PLANNING DEPARTMENT STAFF REPORT AND FINDINGS

ROLLING MEADOWS MINOR PARTITION – PRELIMINARY PARTITION APPROVAL (File MP 23–15)

Preliminary Partition Plan Map

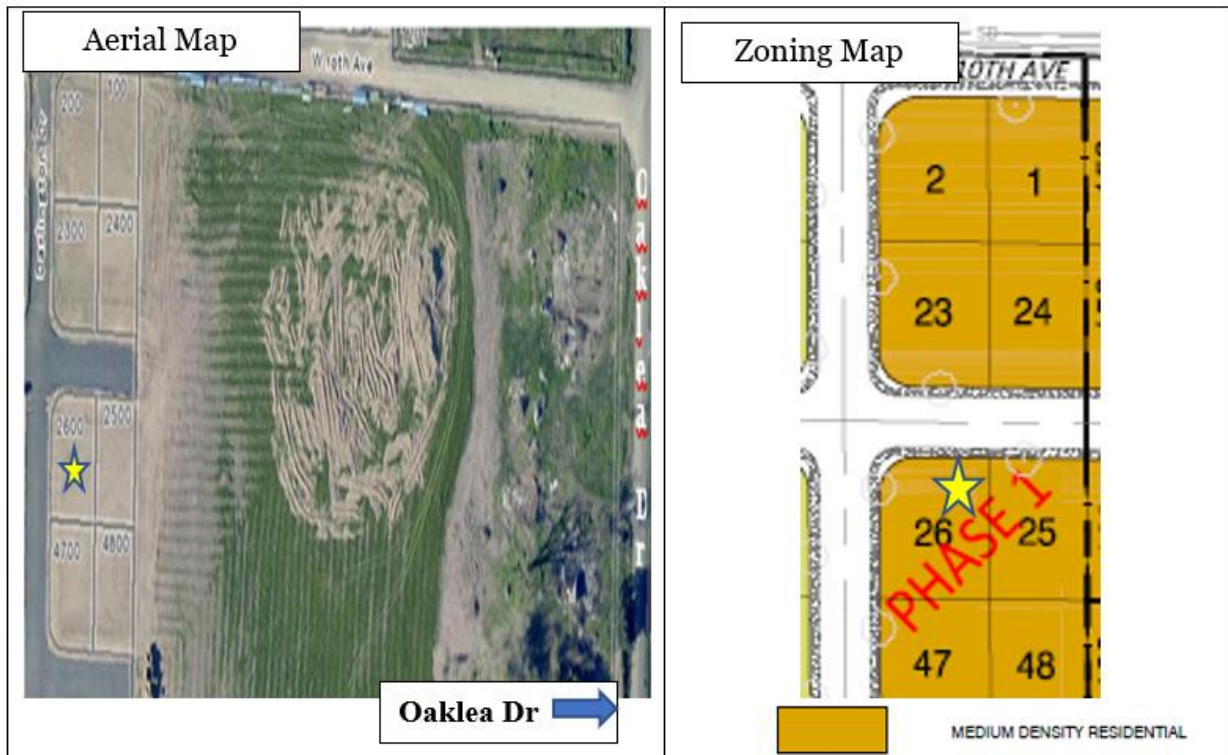
Finding 7: The preliminary plan has the dimensions of both parcels. The final plat must have this information.

Finding 8: The preliminary plan depicts the boundaries of all contiguous property; with property on the east, west and south under the same ownership and owned by the applicant.

Finding 9: The preliminary plan has the date, north point and scale of the drawing. The dimensions of the property are adequately identified as adjacent tax lots are identified and numbered. The legal description of the property is Lot 26, Rolling Meadows PUD Phase 1. Neither the preliminary partition plan nor the supplemental materials identify the assessor's account number (Act #1914516).

Finding 10: The name and address of the owner/partitioner is present on the preliminary plan and its telephone number. However, the telephone number is included on the application form. The applicant's representative's name and address is listed on the preliminary plan as is Marcus Cross, the applicant's surveyor.

Finding 11: The preliminary plan shows 10th Avenue and Darlington Avenue and their right-of-way widths of 50 feet.

Finding 12: The preliminary plan depicts the layout of the proposed parcels and their number. The complete dimension of each parcel is included and their square footage.

Finding 13: The preliminary plan shows that the lot is vacant. The preliminary plan lists the setback standards associated with the R2 Zone.

Finding 14: The preliminary plan shows the location of two dedicated water easements and a public utility easement. These easements were dedicated as part of the approval of Phase 1 of the Rolling Meadows Subdivision.

Finding 33: The preliminary plan shows a 5' x 15' water easement, a 5' x 7.5' water easement, and a 10-foot wide public utility easement; all dedicated to the city.

Condition of Approval #1: The final plat must show all easements. All easements must be recorded and the public utility easements dedicated to the City prior to final plat approval.
